UNITED STATES  
DEPARTMENT OF THE INTERIOR  
BUREAU OF LAND MANAGEMENT

FORM APPROVED  
OMB NO. 1004-0135  
Expires: July 31, 2010**SUNDRY NOTICES AND REPORTS ON WELLS**  
*Do not use this form for proposals to drill or to re-enter an abandoned well. Use form 3160-3 (APD) for such proposals.***SUBMIT IN TRIPLICATE - Other instructions on reverse side.**

Well Name: <b>KACHINA 5 FEDERAL 3</b>		Field: <b>SOUTH CORBIN</b>	
Location: <b>1980' FSL &amp; 1980' FWL; SEC 5, T18S, R33E</b>		County: <b>LEA</b>	State: <b>NM</b>
Elevation: <b>3972' GL</b>		Spud Date: <b>1/31/92</b>	Compl Date: <b>4/26/92</b>
API#: <b>30-025-31517</b>	Prepared by: <b>Ronnie Slack</b>	Date: <b>11/14/13</b>	Rev:

**Kachina 5 Federal 3**  
**30-025-31517**  
**Devon Energy Production**  
**May 09, 2014**  
**Conditions of Approval**

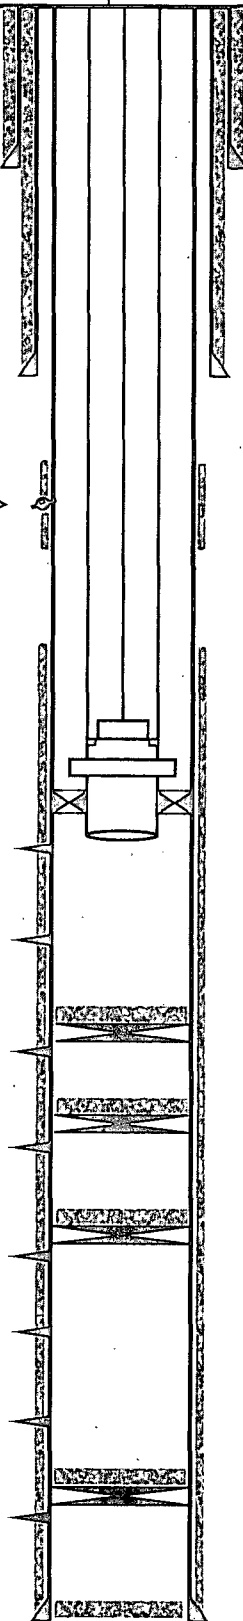
Devon Energy Production Company, LP respectfully requests approval to squeeze cement in the following interval:

Hole in casing at 5,020' to 5,054'.  
Top of cement @ 7,030' based off of CBL log on file  
Well isolated @ 9,407' and good test to 1,000 psi

- 1) Set Cement Retainer at 4,900'
- 2) Sting into retainer with 2-3/8", 4.7# Tubing
- 3) Establish injection rate
- 4) Squeeze suspected leak with up to 500 sacks of 14.8 ppg (1.33 yield) C cement + Fluid loss additives

Casing Leak interval: 5020' to 5054'. (actual cement volume will be dependent on injectivity test)

- 1. Operator is approved to squeeze as proposed.**
- 2. Must conduct a casing integrity test to 1,000 psi for 30 minutes after squeeze job. Submit results to BLM. Notify BLM if test fails.**
